SUBJECT: Forwards responses to Structural Engineering Branch 810403 request for addl info re 801201 submittal for expansion of spent fuel storage capacity.

H. B. ROBINSON STEAM ELECTRIC PLANT UNIT NO. 2
DOCKET NO. 50-261
LICENSE NO. DPR-23
REQUEST FOR ADDITIONAL INFORMATION CONCERNING
SPENT FUEL POOL EXPANSION

RESPONSES TO STRUCTURAL ENGINEERING BRANCH
REQUEST FOR ADDITIONAL INFORMATION
H. B. ROBINSON UNIT 2 FUEL STORAGE MODIFICATION

FIGURE 1

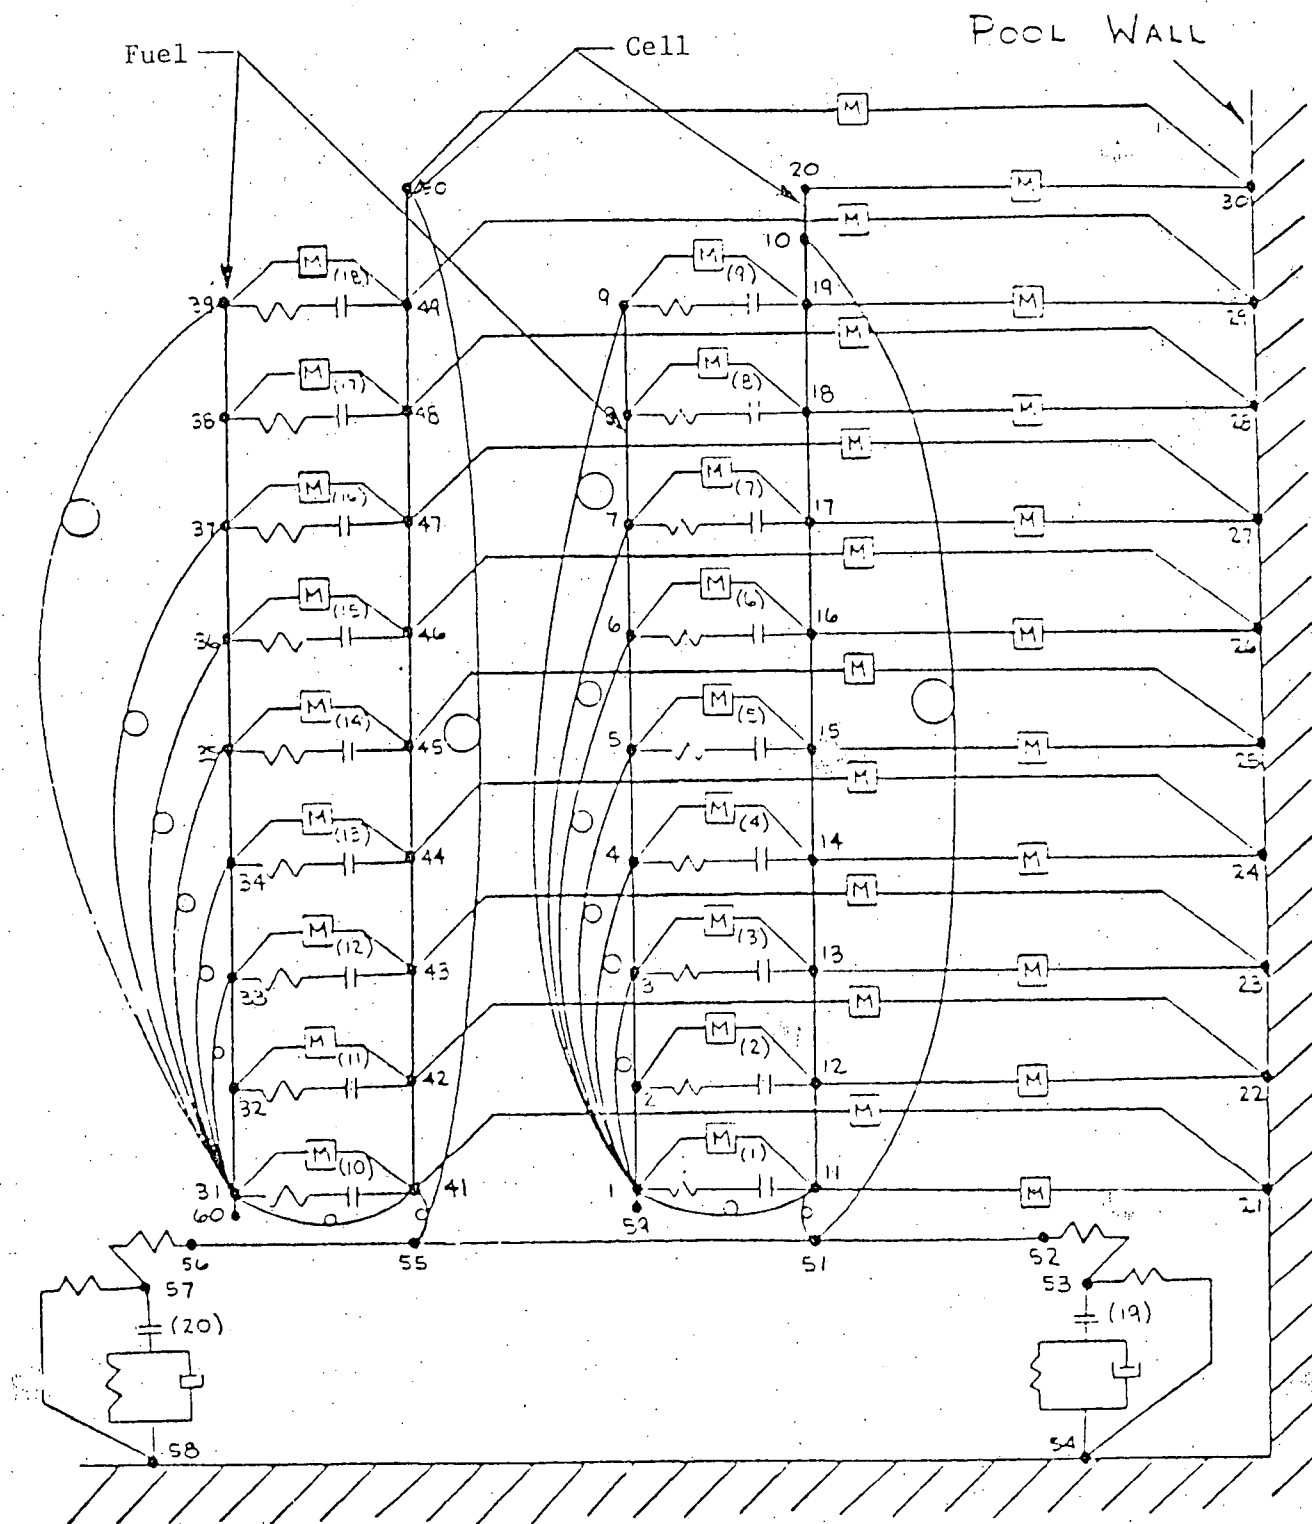
QUESTION: 4. Provide the nonlinear finite element model used in the time history analysis. Describe in detail how the nonlinearities due to gaps, friction losses and boundary conditions are accounted for in the model and analysis. Discuss, also, the analysis and provide justifications.

4. The H. B. Robinson nonlinear fuel rack model, shown in Figure 1, is a simplified flow-cell representation of a spent fuel storage rack with a fuel assembly contained within each cell. This model has two cells so that the analysis can be performed for fully loaded, partially loaded, and empty rack conditions by using two fuel assemblies, one fuel assembly, and no fuel assemblies, respectively.

Impact elements are used to model the impact phenomena between the fuel assembly and cell caused by the fuel/cell gaps. Friction interface elements are used at the rack supports to model liftoff, sliding and tipping behavior of the fuel rack. Since the fuel racks are located in the spent fuel pool which is filled with water, the effects of water on the response of the fuel rack system is included. The effects of surrounding water and water within cell assembly are modeled by using fluid (mass) elements. The spent fuel pool and fuel rack geometrical properties are used in determining the magnitude of hydrodynamic mass for the fuel rack system. The structural characteristics of the nonlinear fuel rack seismic model are obtained from the detail linear finite element model.

To obtain the nonlinear response of the fuel racks, the WECAN Computer Code was used. WECAN is a general purpose proprietary finite element code developed by Westinghouse for performing structural analysis. The WECAN Computer Code has the capability to handle nonlinearities due to impact and sliding between structural components.

FIGURE 2 H. B. Robinson Unit 2 Horizontal SSE Acceleration Design Time History

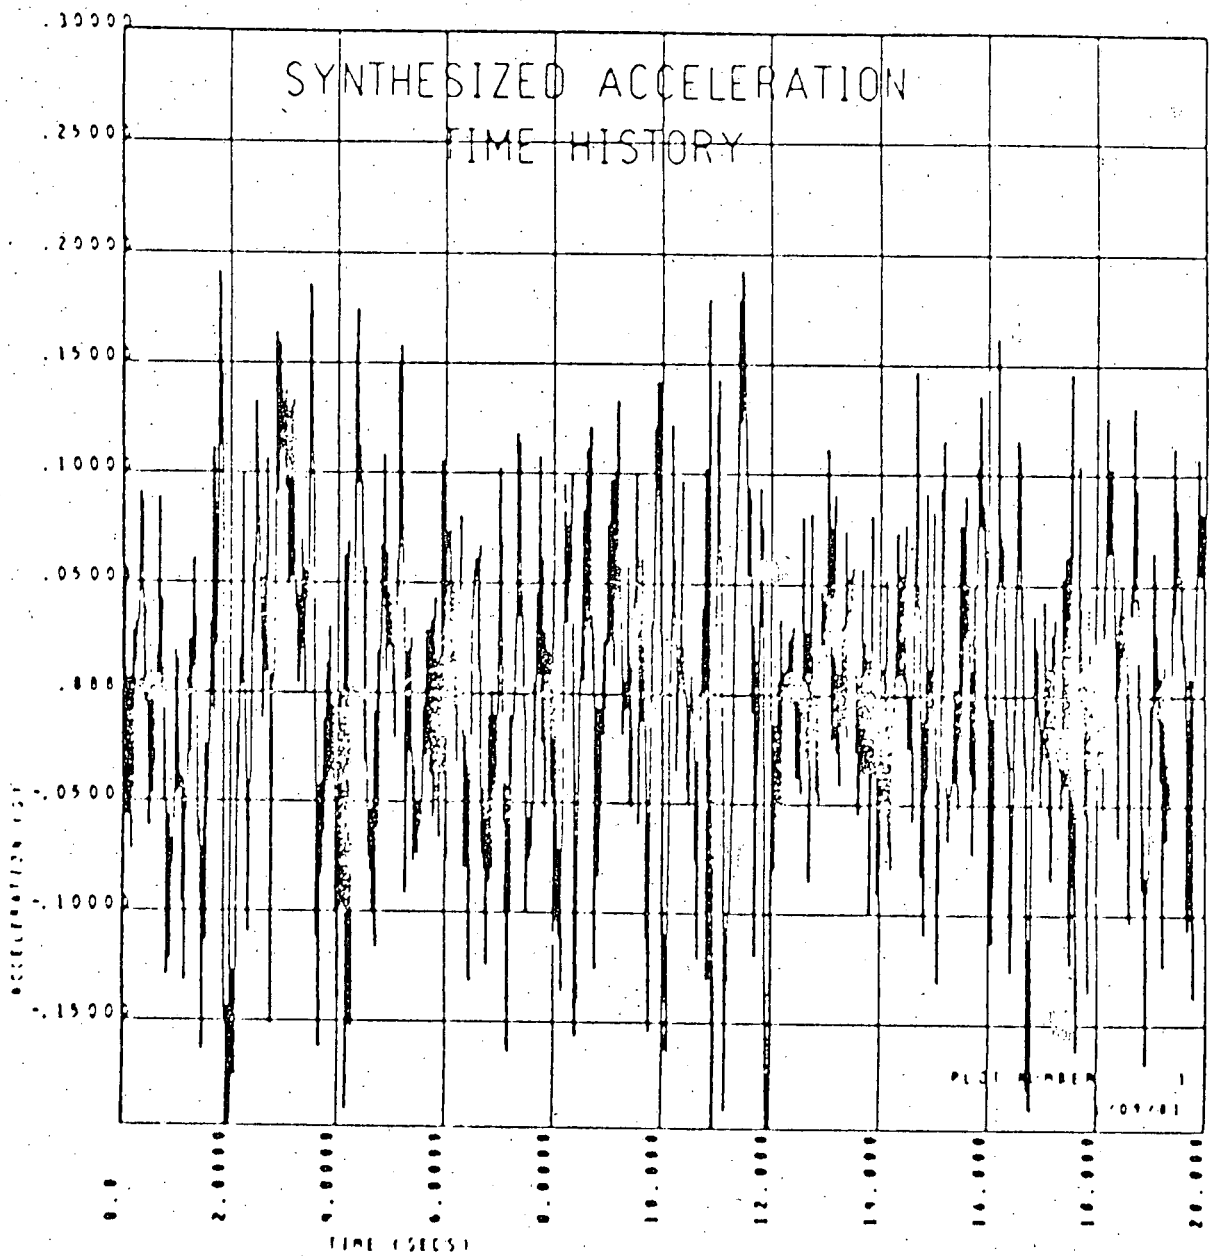
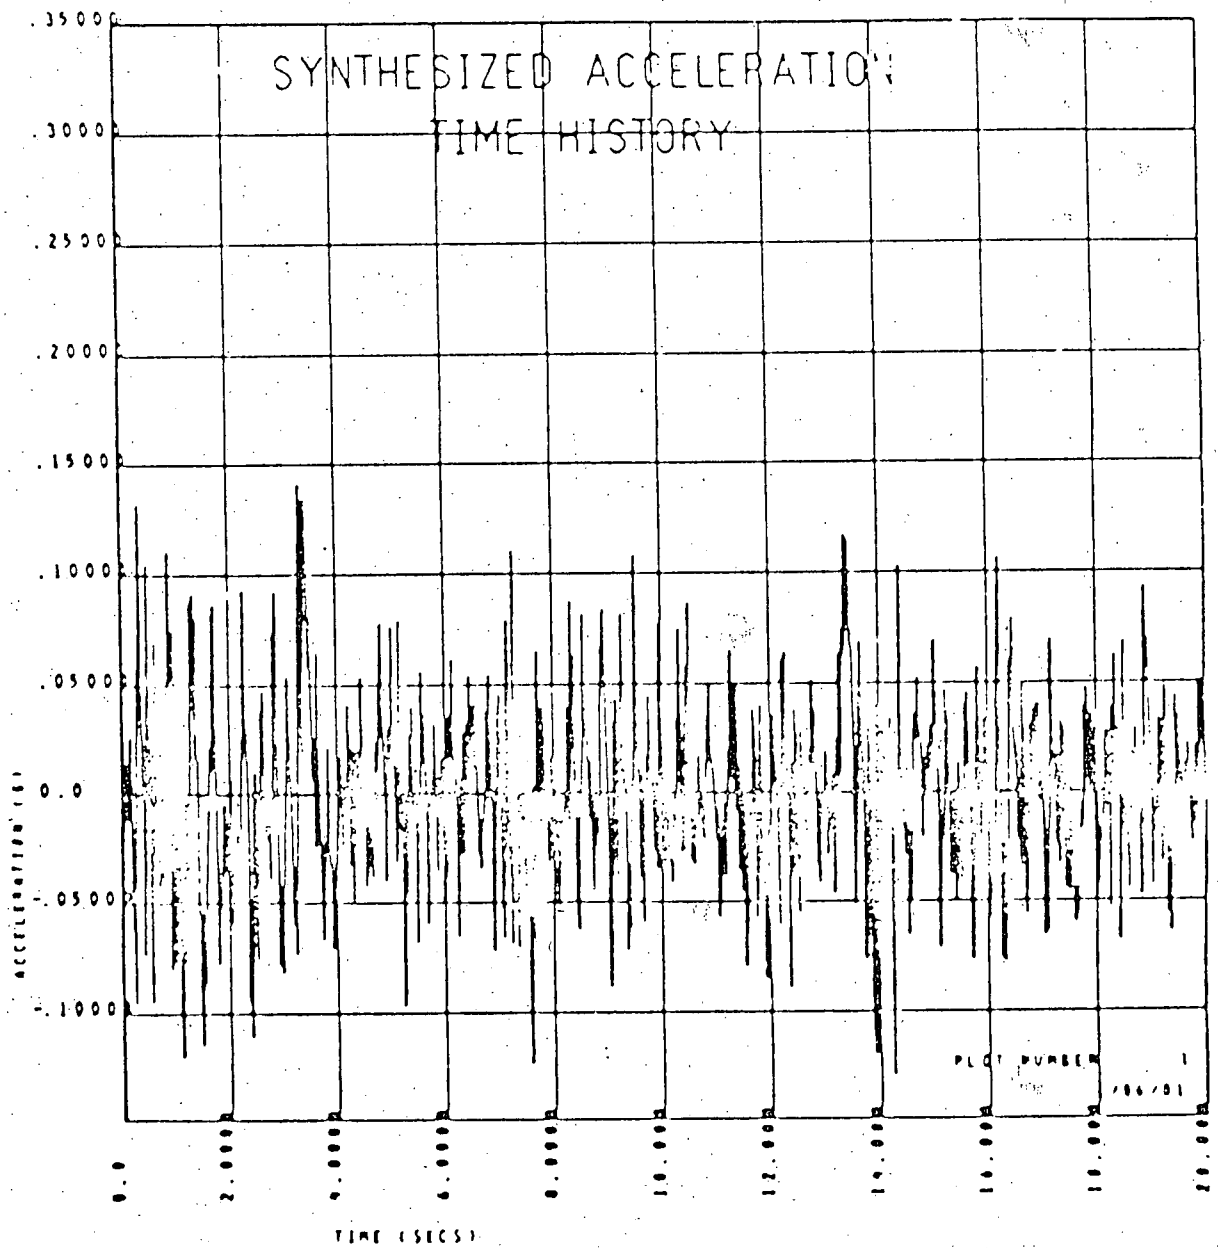
QUESTION: 10. Provide and justify the time history and floor response spectra used in the seismic analysis of the fuel rack assembly.

RESPONSE: 10. The seismic time history excitation used in the nonlinear analysis of the fuel rack assembly was developed from the ground response spectrum and damping values contained in the USNRC Regulatory Guides 1.60 and 1.61 respectively, using the ground acceleration of 0.20 G's horizontally and 0.134 G's vertically for the SSE event. Using this information, the design time history was synthesized. The synthesized acceleration time history for horizontal SSE and vertical SSE are given in Figures 2 & 3. In addition, response spectra developed from the synthesized time histories are represented
